Access Compliance Report

Public Rights-of-Way

Intersection ID: 13905	Main Street: CENTRAL_AV	Cross Street: SHERIDAN_DR	Location: SW
ADA ID: 2FBDE8CBAF21	Ramp Type: BlendTrans1	Initial Pass/Fail: Fail	Overall Compliance: No
Severity Score: 30			
Codes/Mitigation Info/Possible Solution		Field Measurements/Component Compliance

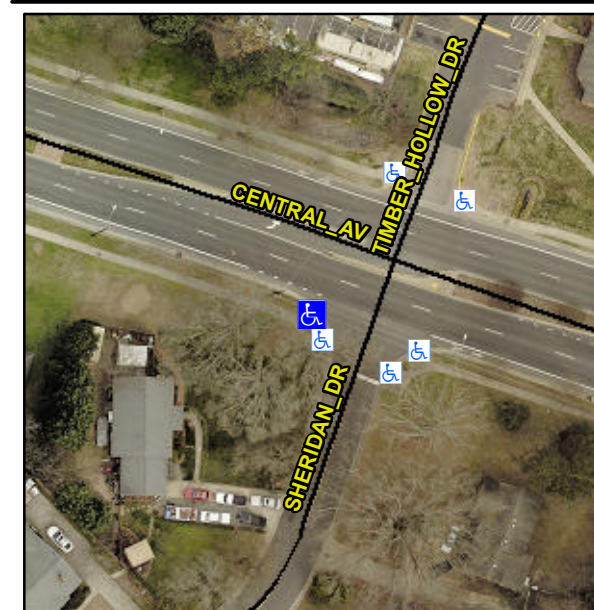
Not Found, R304.5.1, R304.5.3

Compliance	Description	Data	Compliance	Description	Data
N/A	Ramp Length (in)	89.0	Yes	BlendTrans Slope (%)	4.2
No	Ramp Width (in)	32.5	No	BlendTrans XSlope (%)	5.6
N/A	Flare Type LT	N/A	N/A	Flare Type RT	N/A
N/A	Flare Slope LT (%)	N/A	N/A	Flare Slope RT (%)	N/A
N/A	Flare Traversable LT?	N/A	N/A	Flare Traversable RT?	N/A
N/A	Landing Length (in)	N/A	N/A	DWS Provided?	N/A
N/A	Landing Width (in)	N/A	N/A	DWS Contrast?	N/A
N/A	Landing Slope (%)	N/A	N/A	DWS Length (in)	N/A
N/A	Landing X Slope (%)	N/A	N/A	DWS Full Width?	N/A
N/A	Landing Curb? (Y/N)	N/A	N/A	DWS Offset (in)	N/A
N/A	Shared Landing?	N/A			
N/A	Gutter Ponding?	N/A	N/A	Gutter Slope (%)	N/A
N/A	Gutter Lip Ht (in)	N/A	N/A	Gutter X Slope (%)	N/A
N/A	Painted X Walk1?	No	N/A	Painted X Walk2?	N/A
	X Walk 1 Direction	To N		X Walk 2 Direction	N/A
	X Walk 1 Width (in)	N/A		X Walk 2 Width (in)	N/A
	X Walk 1 Slope (%)	5.9		X Walk 2 Slope (%)	N/A
	X Walk 1 X Slope (%)	0.7		X Walk 2 X Slope (%)	N/A

Remove & Replace Curb Ramp With Two New Directional Ramps or Equivalent.
